**Subject: Quarterly Performance Report for Remediation Systems
Tronox LLC, Henderson, Nevada
July – September 2007**

Quarterly Performance Report for Remediation Systems Tronox LLC, Henderson, Nevada July – September 2007

Re: **Tronox LLC (TRX)**
NDEP Facility ID #H-000539
Nevada Division of Environmental Protection Response to:
*Annual Remedial Performance Report for Chromium and Perchlorate, Tronox LLC,
Henderson, Nevada*
Dated August 29, 2007

Tronox Response to October 5, 2007 NDEP comments on the Annual Remedial Performance Report for Chromium and Perchlorate dated August 29, 2007

Tronox Henderson Groundwater Treatment Block Flow Diagram

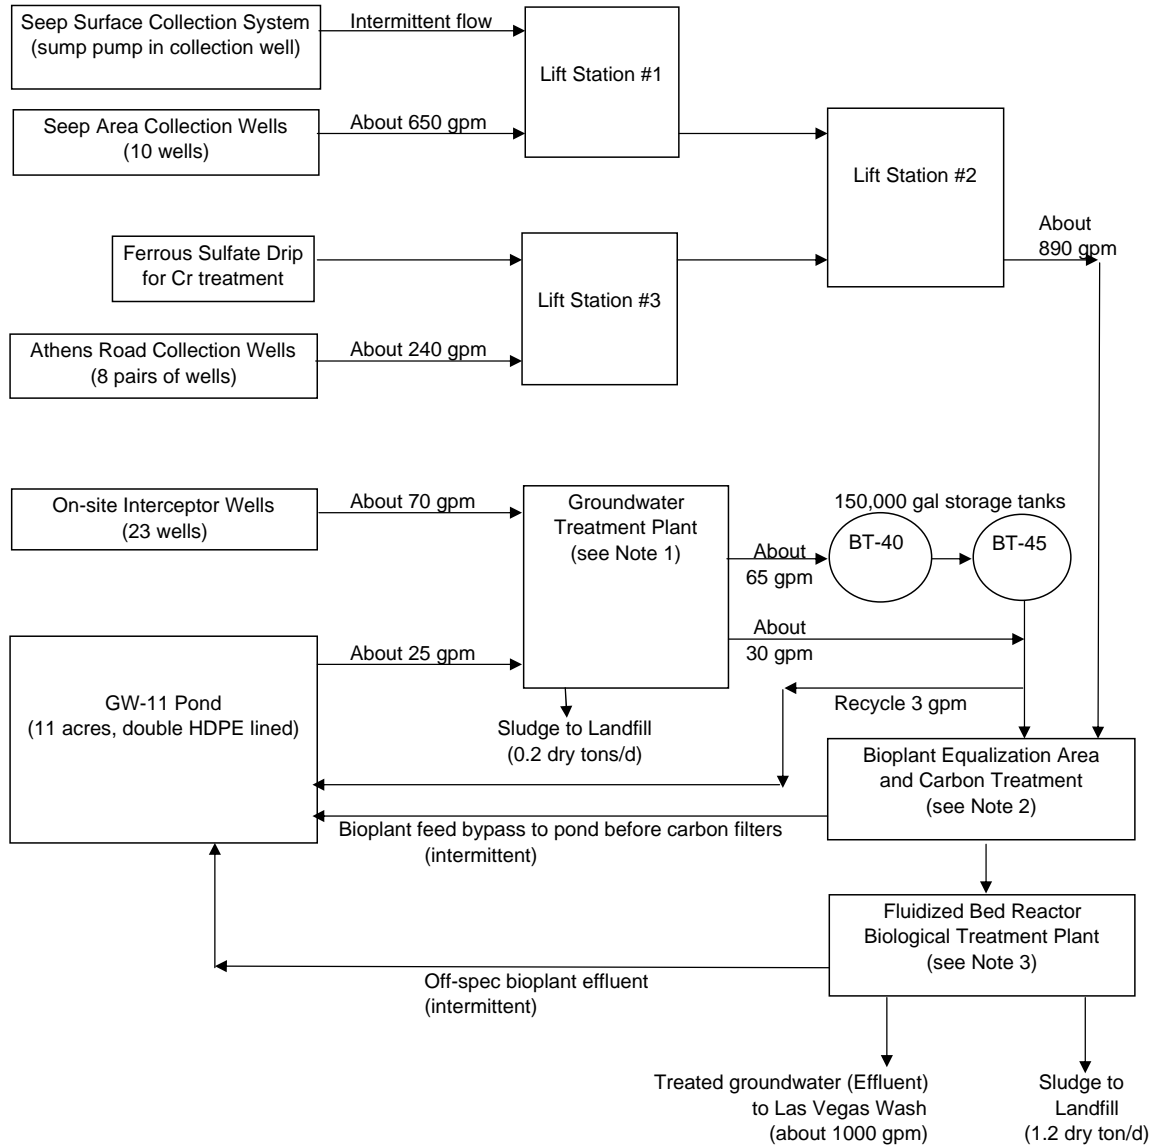
- b. Figure 7, Tronox Henderson Groundwater Treatment Block Flow Diagram, in Section 3.2, TRX states that the influent to the GWTP includes "about 25 gpm from GW-11" but Figure 7 states that the influent to GWTP includes only "about 20 gpm" from GW-11. Please revise accordingly.

- c. Figure 7, TRX states that the three activated carbon vessels "remove organics which could harm bacteria". Please discuss this matter with the NDEP and provide analytical data to substantiate this statement. NDEP does not have sufficient assurance that TRX is monitoring the performance of the carbon vessels in a manner that will be protective of the FBR system.

- d. Figure 7, please add a notation to indicate where the "FBR Influent" and "FBR Effluent" samples are taken.

- b. *The flow from GW-11 to the FBRs has recently been raised from about 22 gpm to 25-27 gpm as a replacement pump was installed. Changing the block flow sheet whenever a small change in plant operation occurs, seems excessive. Tronox proposes to update Figure 7 once each year when the annual report is submitted.*

- c. *Control of the biological treatment plant to meet NPDES discharge requirements is the responsibility of Veolia Water North America, which operates the groundwater collection and treatment systems for Tronox. Veolia samples water from the GAC columns and has analyzed the water for pesticides. The concern that bacteria in the FBRs might be adversely impacted by traces of organics was raised during the design process for the system. The bacteria have proven to be resilient to changes in many operating conditions. Veolia will continue to monitor GAC performance and will replace the GAC as needed.*

- d. *The "FBR Influent" sample is collected following the GAC and polishing filters at a sample point located on the east side of the D-1 building. The "FBR Effluent" sample is collected at the end of the discharge pipeline just upstream of the Pabco Road erosion control structure on Las Vegas Wash. Tronox will add the points to the Figure 7 block diagram as a footnote.*
